**SUBMISSION FROM INNER WEST COUNCIL
TO THE DEPARTMENT OF PLANNING INFRASTRUCTURE AND ENVIRONMENT
ON THE SYDNEY METRO WEST ENVIRONMENTAL IMPACT STATEMENT
(CONCEPT & STAGE 1)**

22 JUNE 2020

Figure 2 - Proposed foreshore connections (Metro West EIS – Concept & Stage, 1 Figure 7-9)

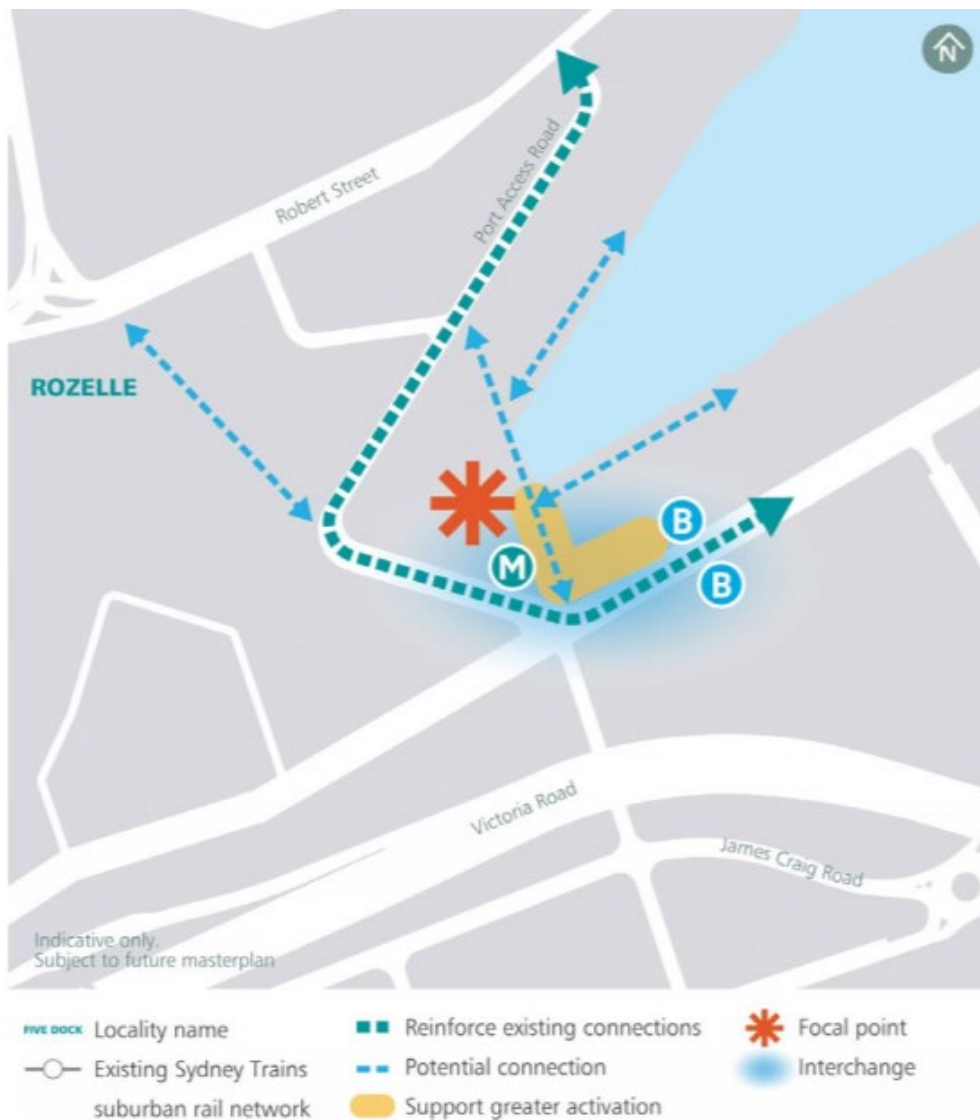
It is considered that the EIS does not clearly demonstrate how the proposed Bays Station will interface with the foreshore. The proposed ‘potential connections’ along the foreshore (as illustrated in Figure 2) are supported.

- connections to the foreshore be designed to optimise the use of the foreshore for active transport/commuting and recreational activities;
- a generous width of walkway, along the water’s edge, should be provided for public access and its dimensions should be planned in conjunction with Council to ensure it is future-proofed in relation to the ultimate population to be served.

Figure 4 – Industrial zoned land under Leichhardt LEP 2013

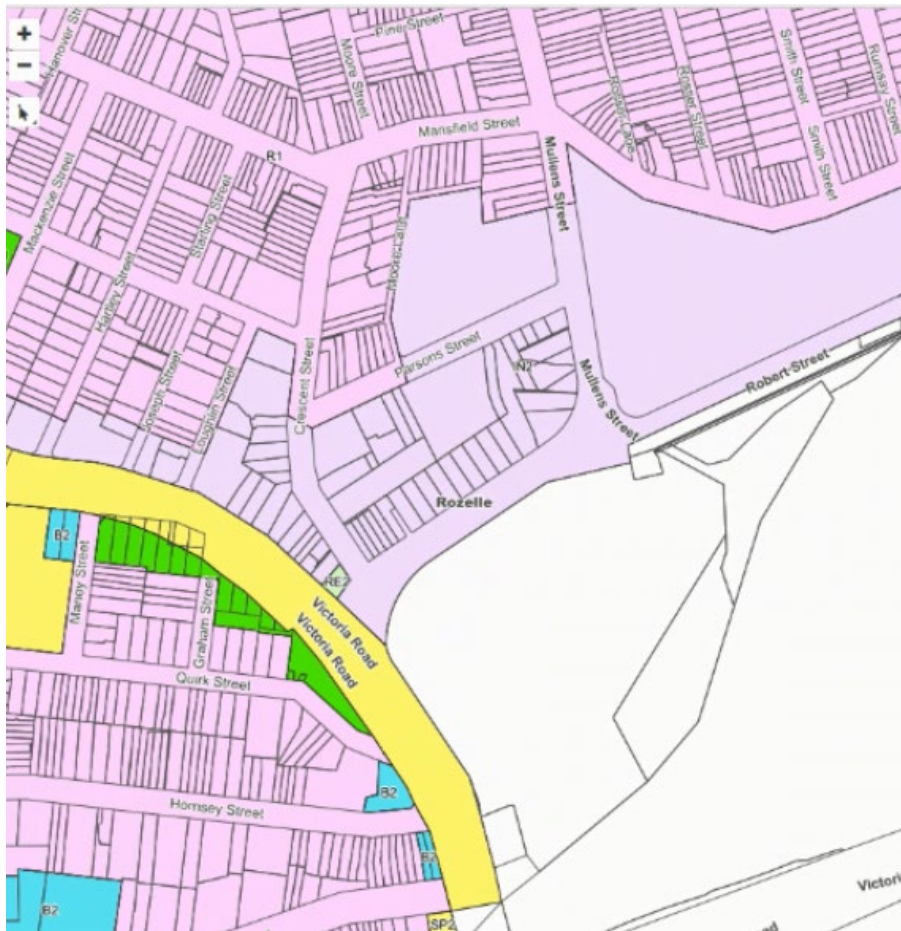
Figure 14-10 of the EIS (Figure 3) indicates existing land uses around The Bays Station, however this figure is inconsistent with the existing zoning under the Leichhardt Local Environmental Plan 2013 (Figure 4).

Council is extremely concerned about the misinterpretation of land use in the area, with industrial zoned sites fronting Victoria Road, Crescent Street, Parson Street and Robert Street being represented as Residential. This illustrated residential use is not reflective of the existing land uses or Council’s policy context.

Council therefore requests that the EIS assessment of existing land uses be revised and that, as well as the existing zoning, Council’s Draft Employment and Retail Lands Strategy be considered in this assessment.
